RE: Blythe Energy Transmission Project Request for Approval of Insignificant Change

BLYTHE POWER PROJECT

**Request for Approval of
Insignificant Project Change
(99-AFC-8)**

**Blythe Transmission Line
Minor Route Realignment and Relocated Connection to
the Blythe Power Plant**

Figure 1: One-Line Diagram

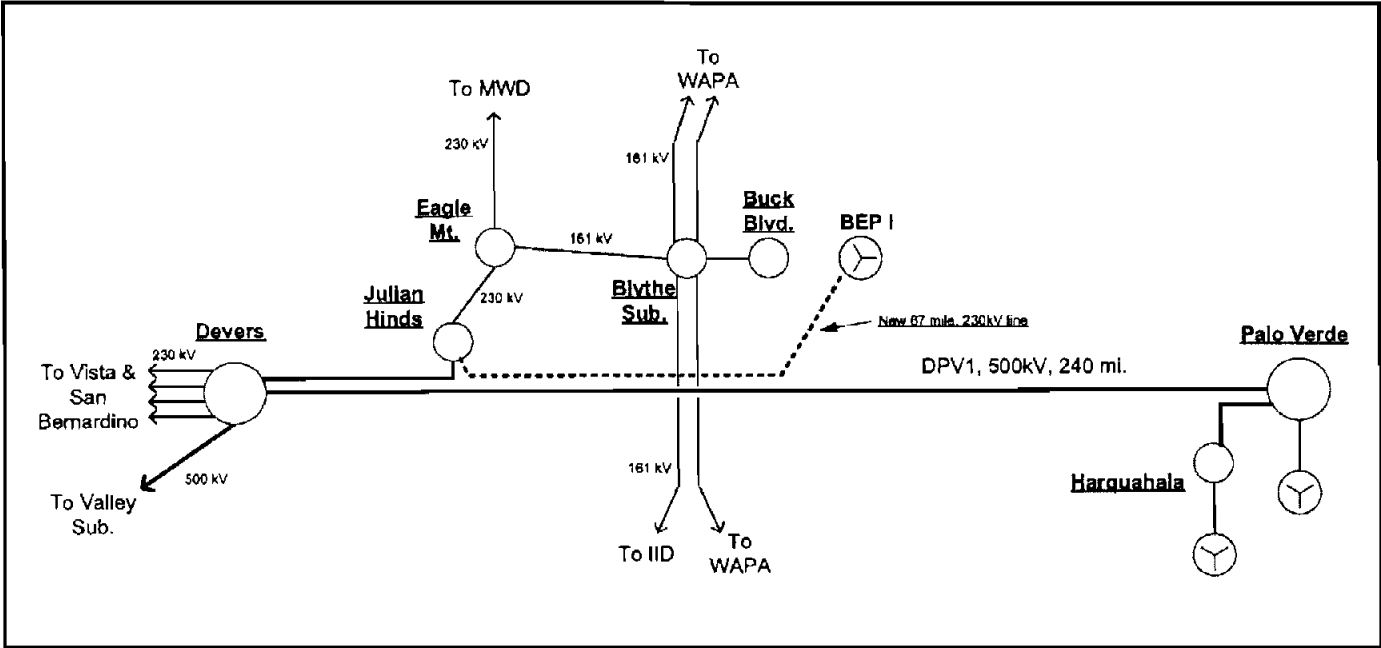
2. Blythe asked the CAISO to provide comments and approval on Option A, which is the least cost alternative (\$12.339 million)¹. Although Option A does not violate any reliability criteria or SPS Guidelines, the CAISO would encourage Blythe to consider other options to eliminate the need of the SPS-0 during the LGIA process with CAISO and SCE. Options that would eliminate the need for the SPS-0 are Options B, C, E and F.

Based on the results of the Revised Facilities Study, the CAISO is granting interconnection approval to the Project for Option A, per Blythe's request, subject to the conditions discussed in the Comment #1 above.
